IN THE DRAWINGS

Annotated Sheets Showing Changes with respect to Figure 10D, 10E, and 12E of the drawings is provided with proposed change indicated in red ink. Corresponding Replacement Sheets are also enclosed. Applicants submit that the drawing as amended does not add new matter given that support is found in the originally filed drawings and in the specification at page 35, lines 1-5.

REMARKS

FIG. 10D

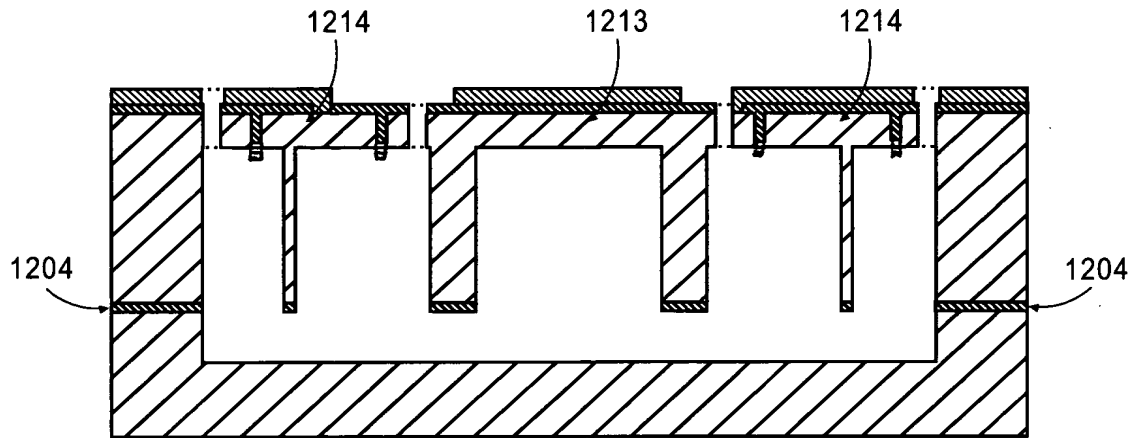
Figures 10D, 10E, and 12E have been amended to conform the formal drawings to the originally-filed drawings. Support for the corrections is found in originally filed Figures 10D, 10E, and 12E of the drawings.
